WINSOME FILING NO. 3  
EL PASO COUNTY, COLORADO  
CONSTRUCTION DOCUMENTS  
CROSS SECTIONS

PROJECT NO.  
196106001

WINSOME FILING NO. 3  
 EL PASO COUNTY, COLORADO  
 PRE DEVELOPMENT GESC PLAN  
 GEC FINAL PLAN

**ALAMAR WAY STA 1038+00 TO 1045+00**

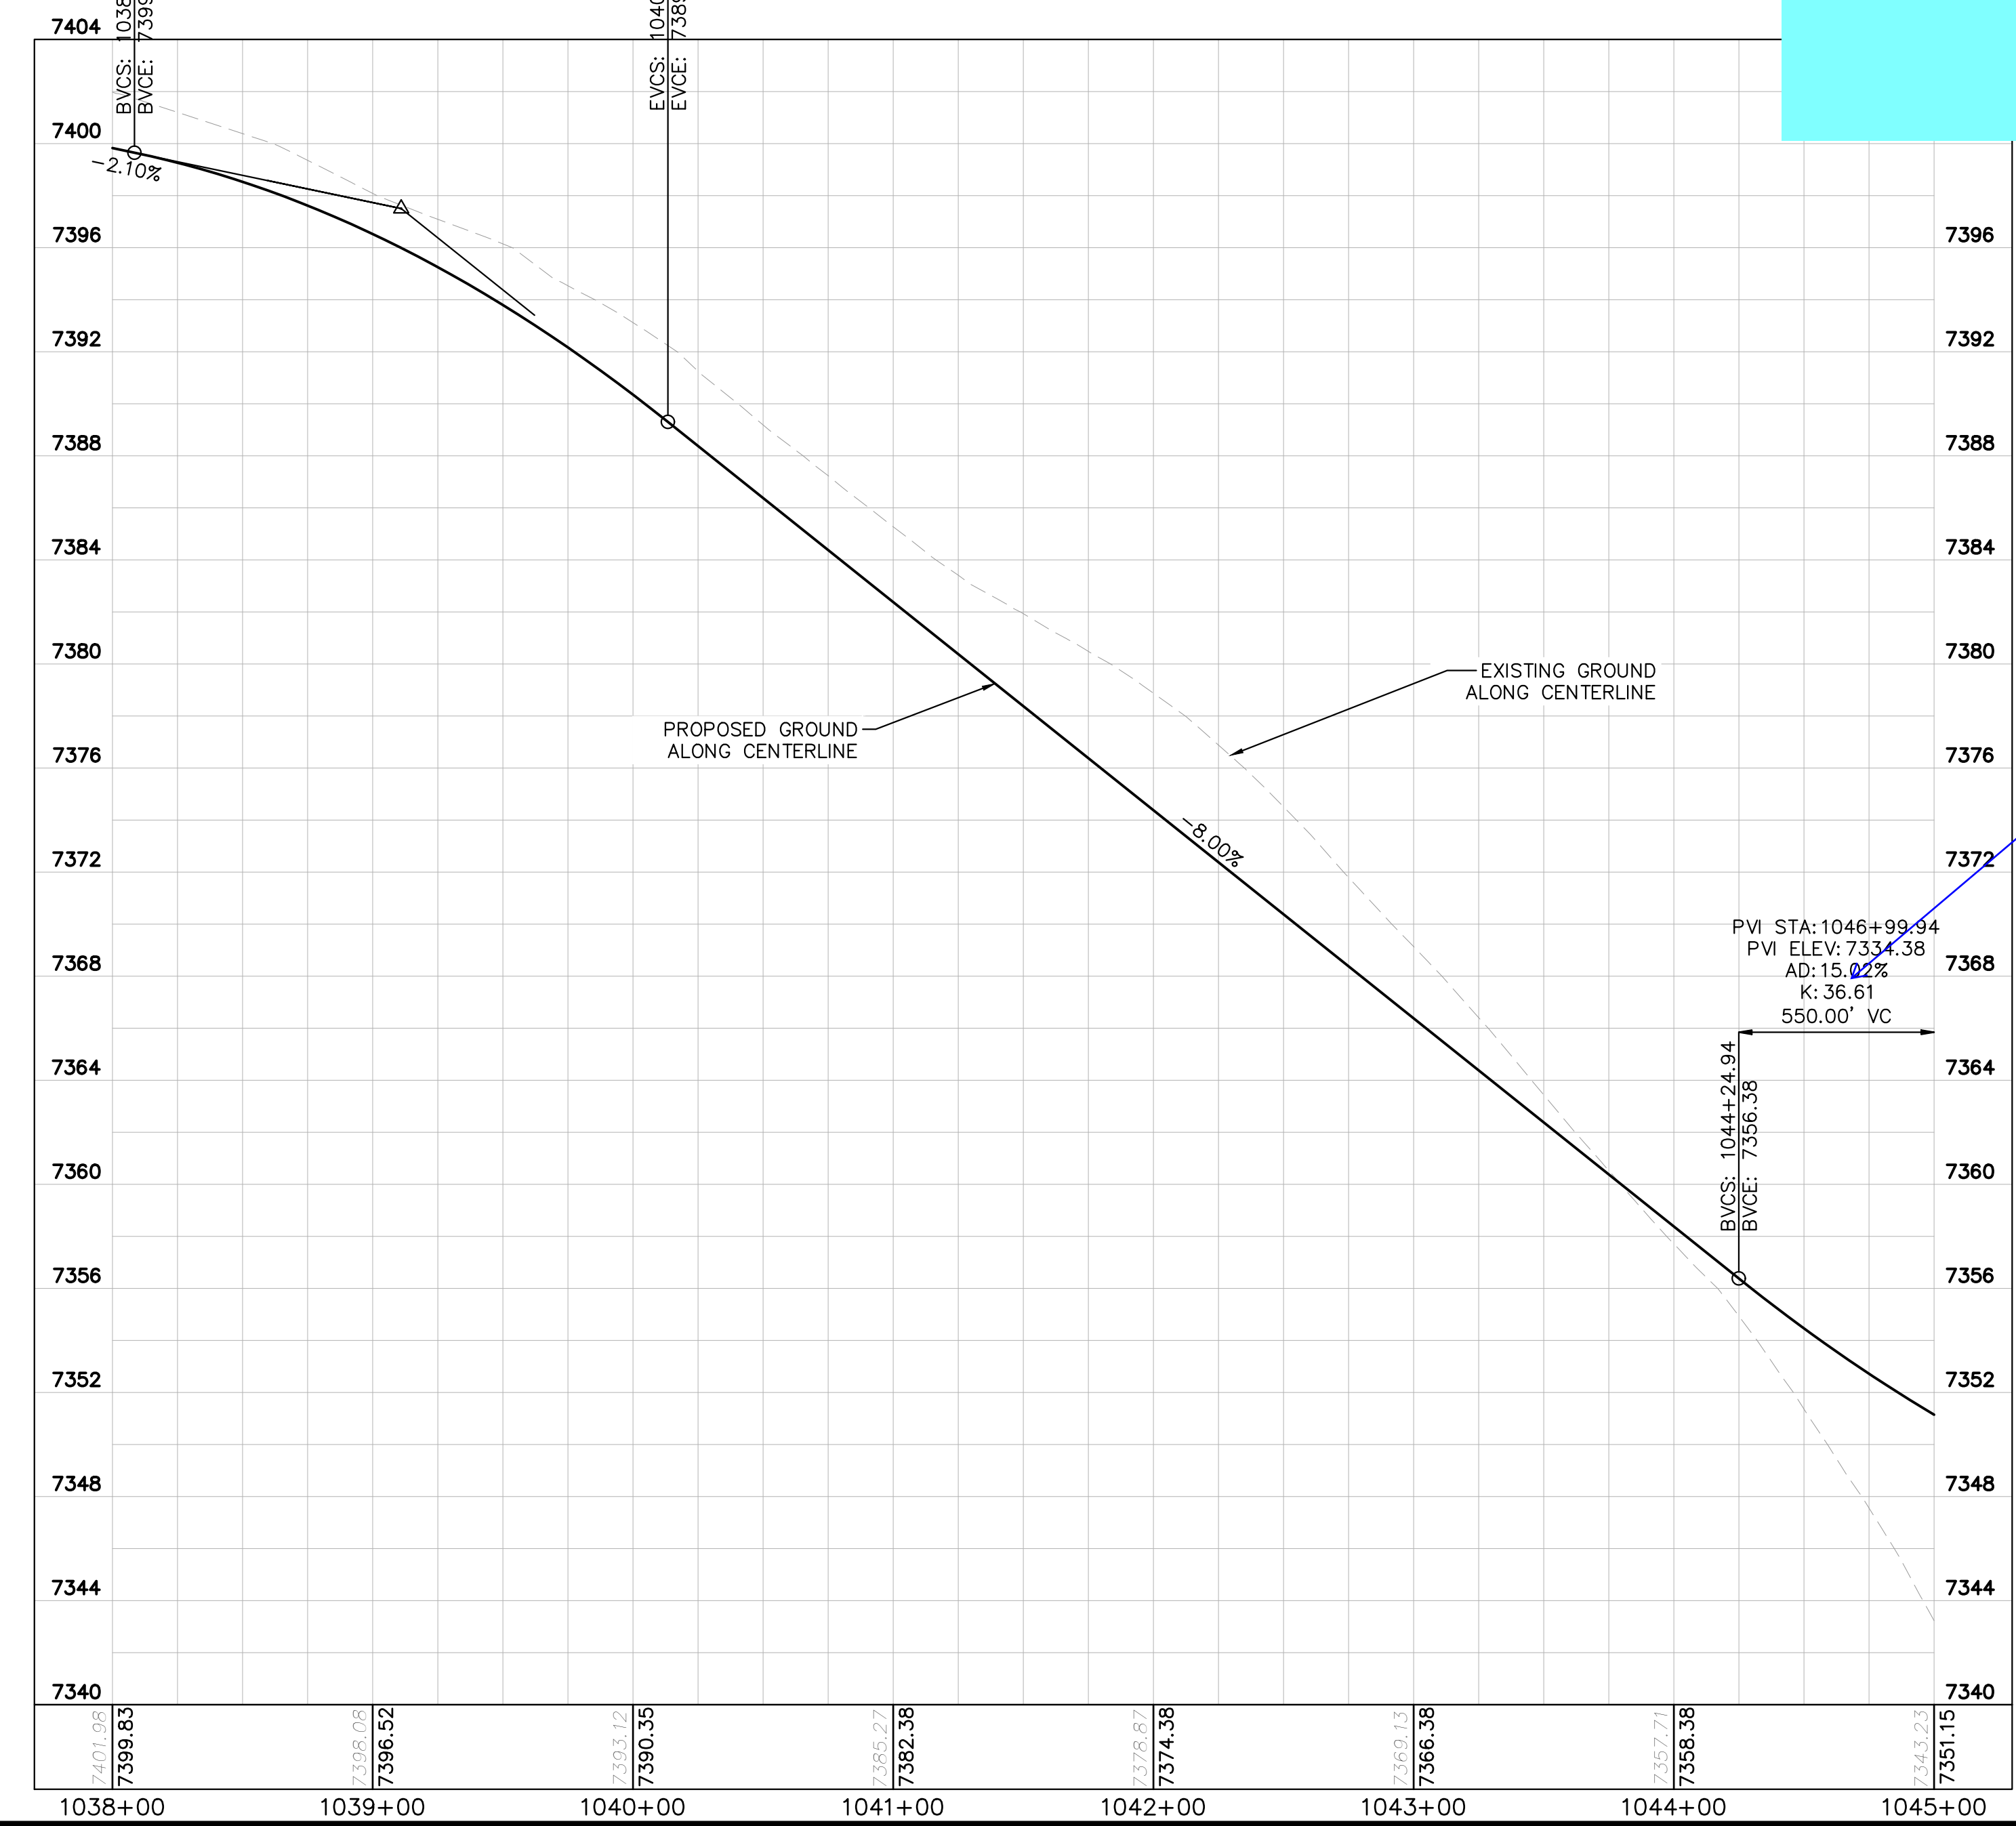
Double check that either this plans or the early grading plans identifies the sections of the road that requires Erosion Control Blanket.

Adjust K value to a minimum of 37 per Table 2-14  
 Adjusted

Erosion Control Blankets and other temporary stabilization are outlined in the EGP plans. Permanent stabilization and lining are outlined on C1.2

SHEET  
 C1.23

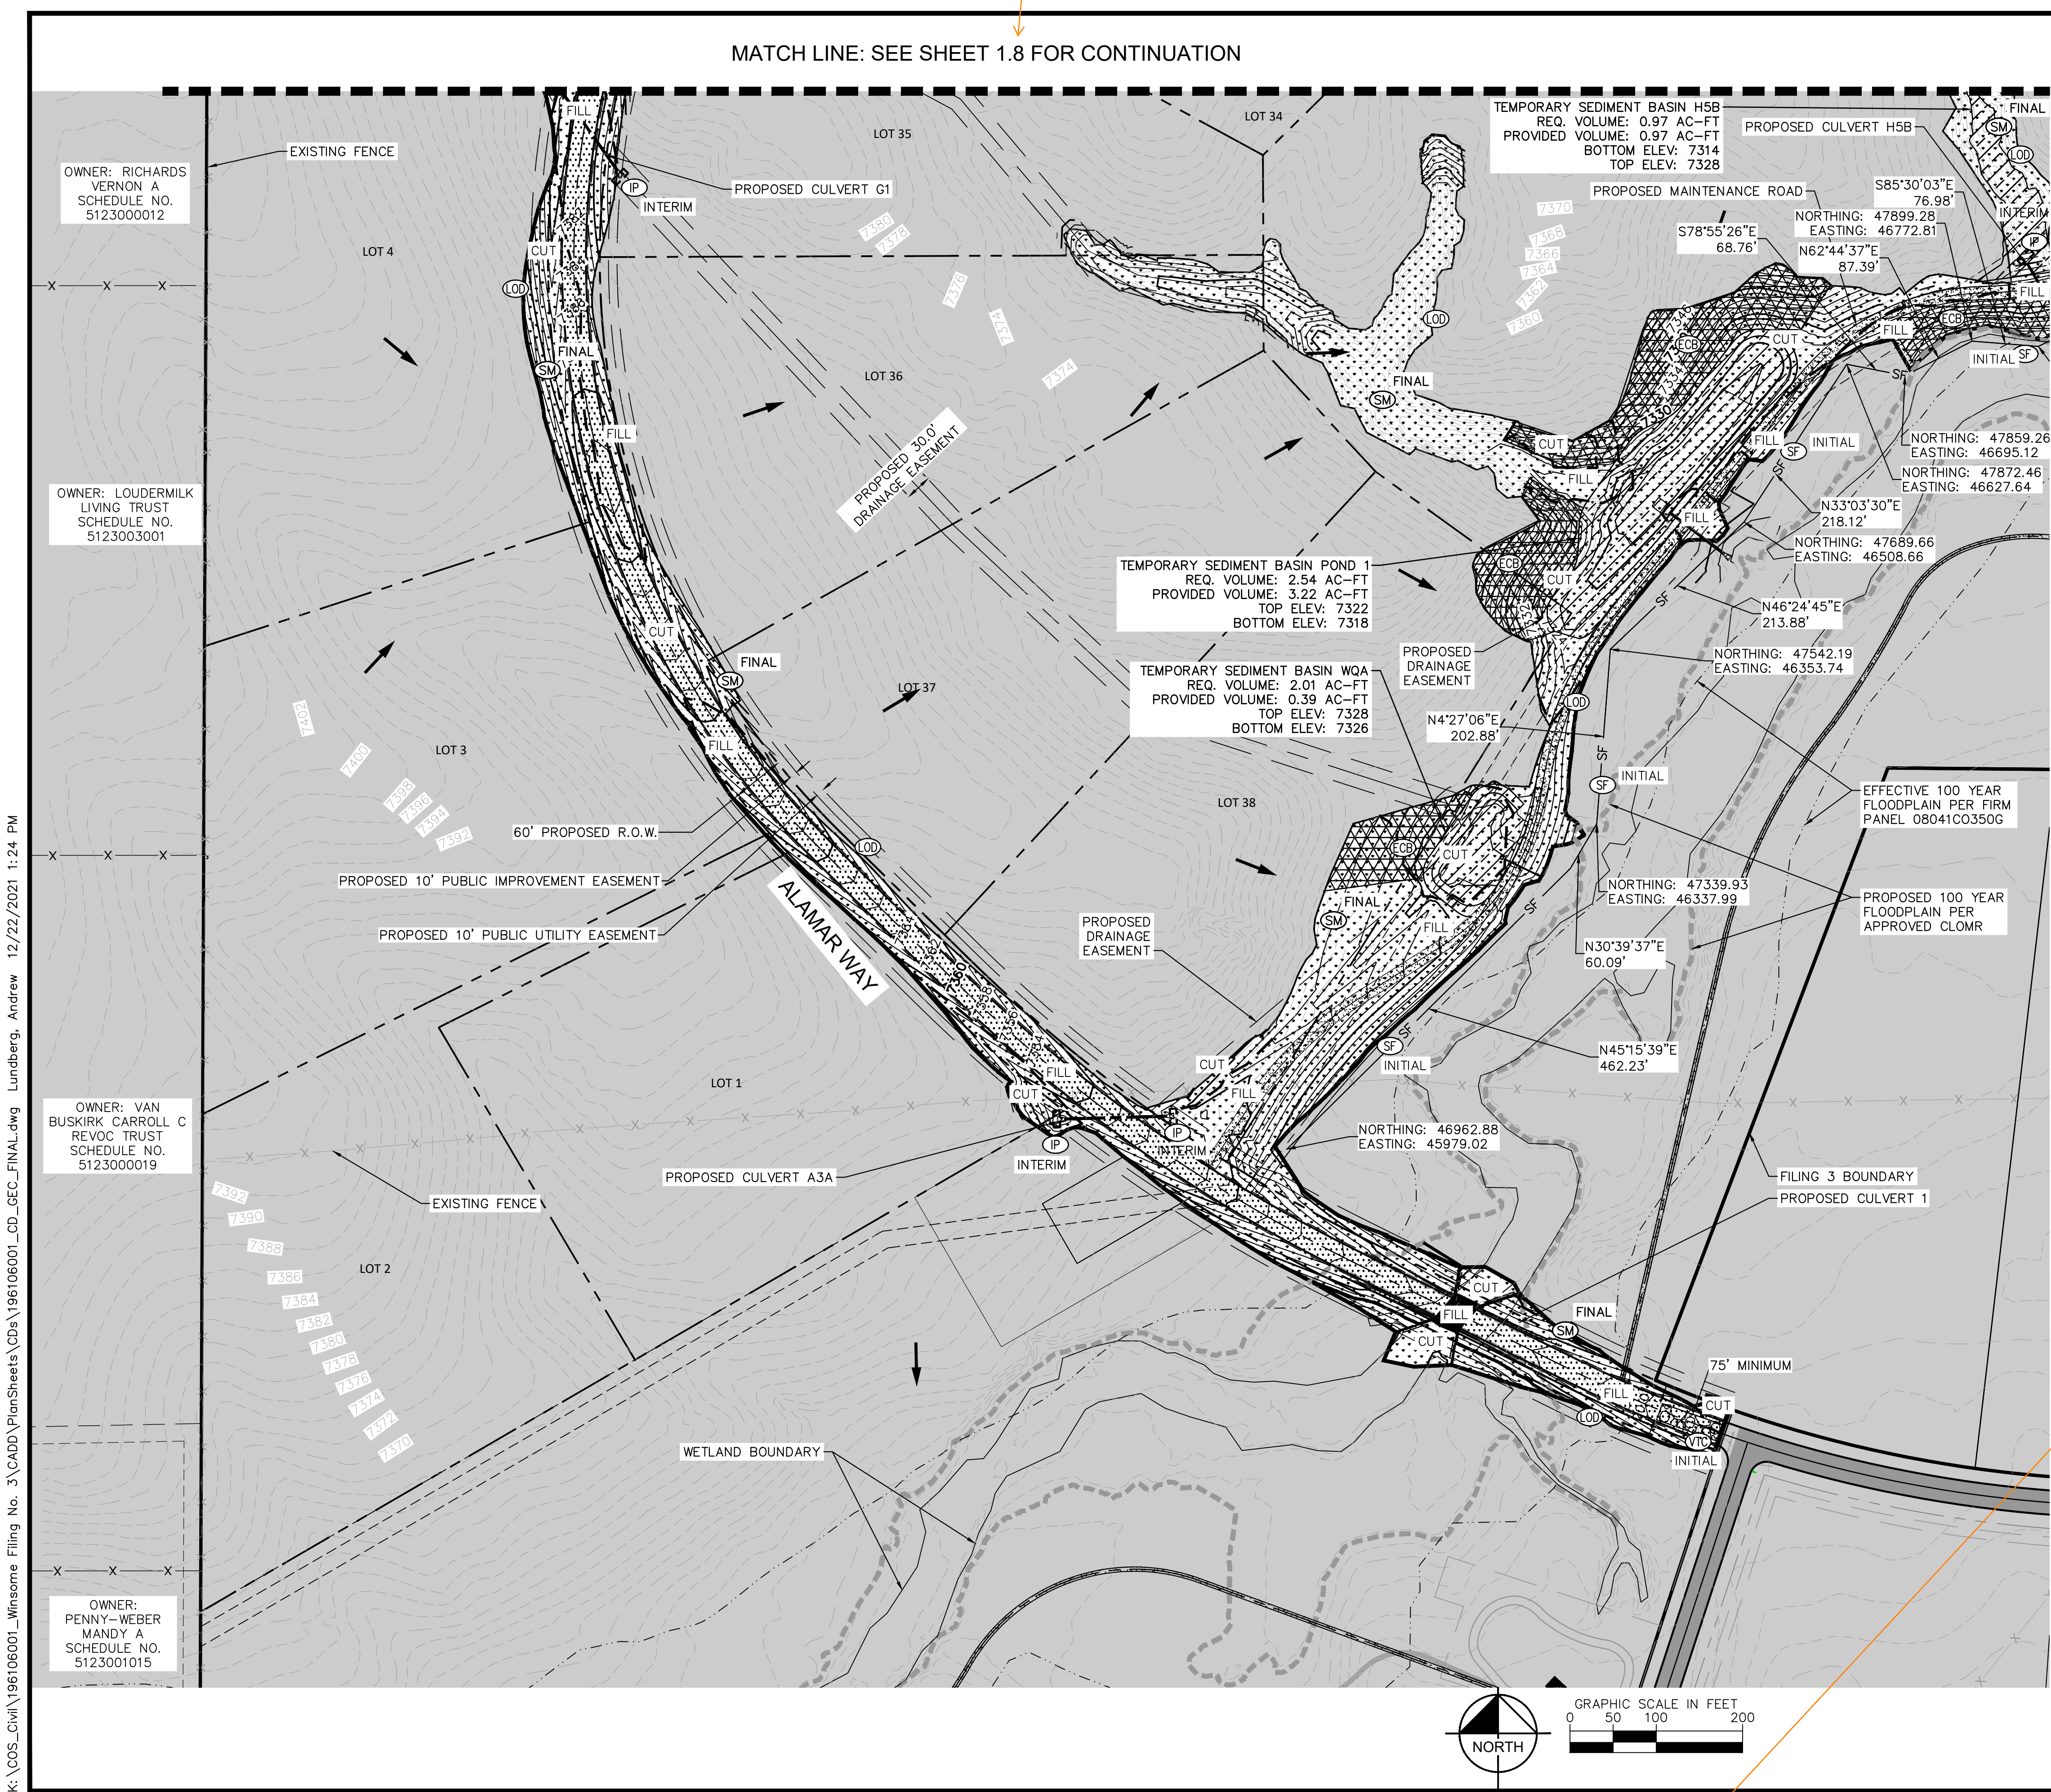
Revise sheet #'s on matchlines on this sheet and all subsequent sheets. This one should be 1.24, for example.

This should instead say "per detail and table." And it would be better if each check dam was shown on the plans to better estimate quantity to input on FAE Form and for install and inspection purposes.

Verify that velocities and flows are such that this substitution is acceptable.

Check dams to be installed a minimum of every 1.5' of vertical fall. Notate spacing and/or include a table for multiple slopes, based on your selected detail, per the example table shown here:

updated fields to reference the correct sheet

SHEET  
C1.26

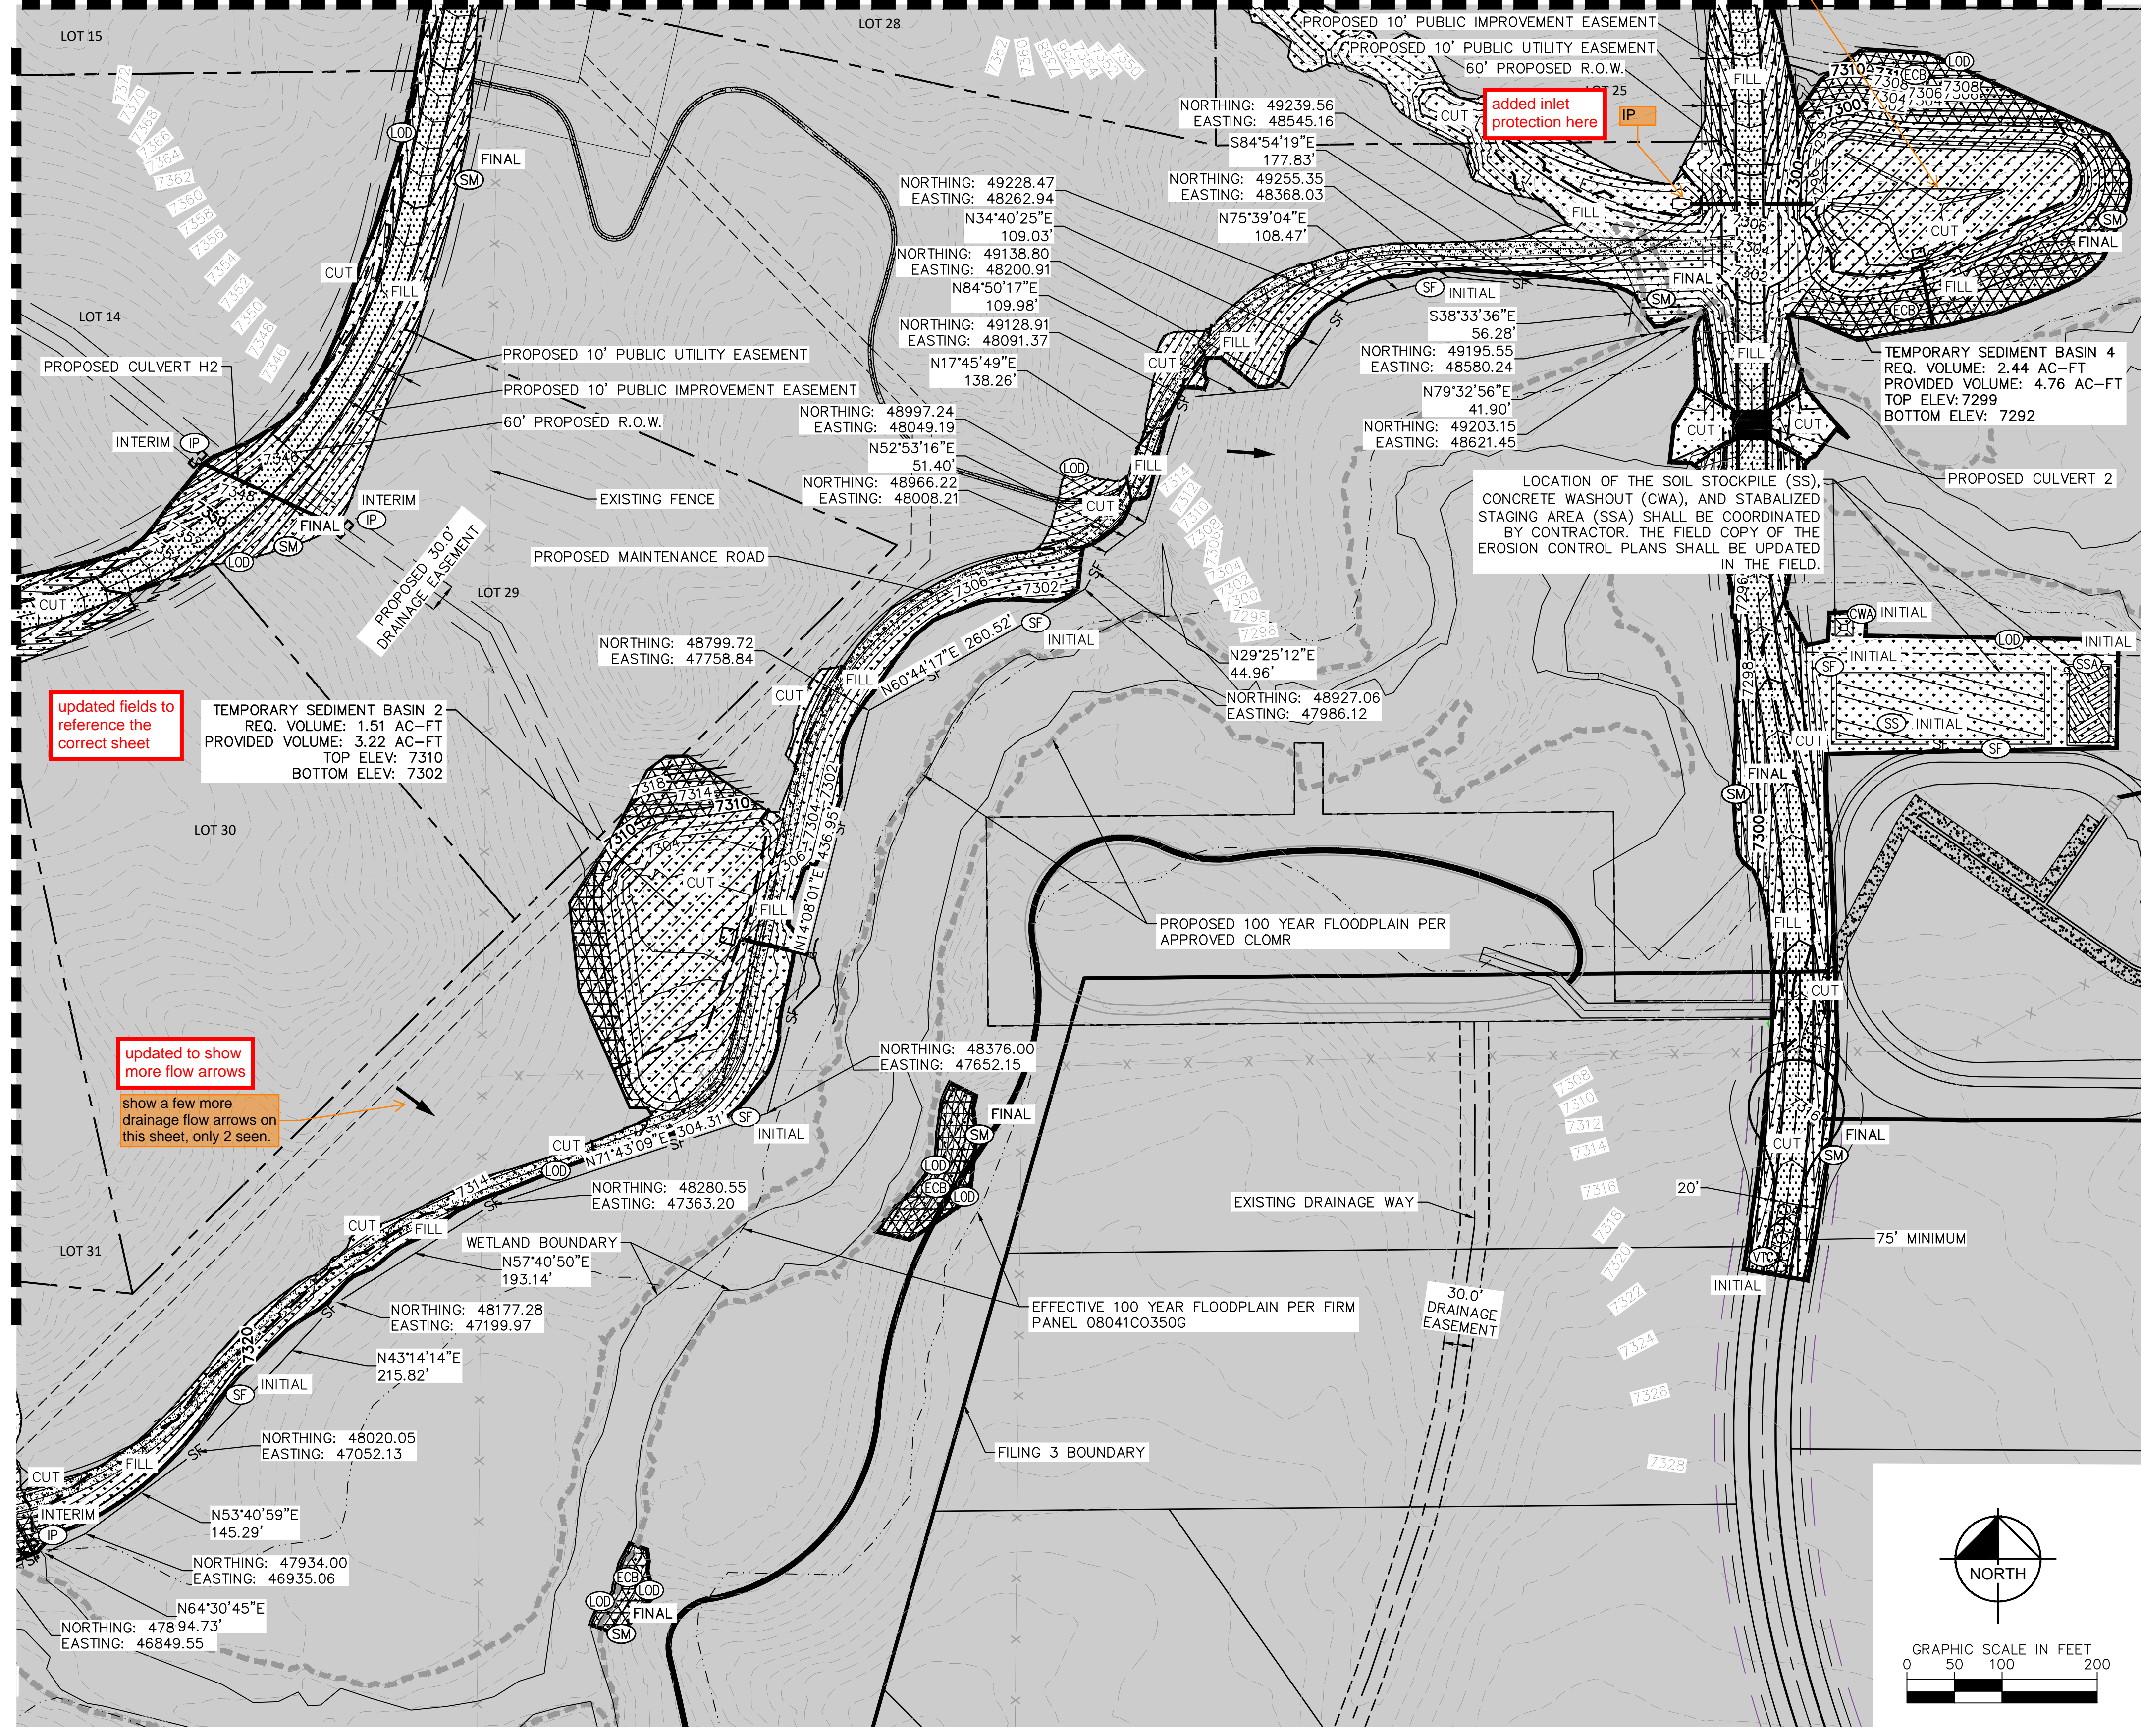
updated to show more flow arrows  
show a few more drainage flow arrows on this sheet, only 2 seen.

The linework for the trickle channel got messed up somehow. Fix as needed.

updated fields to reference the correct sheet

updated fields to reference the correct sheet

previously extracted contours are no longer shown. Trickle channel is showing correctly.
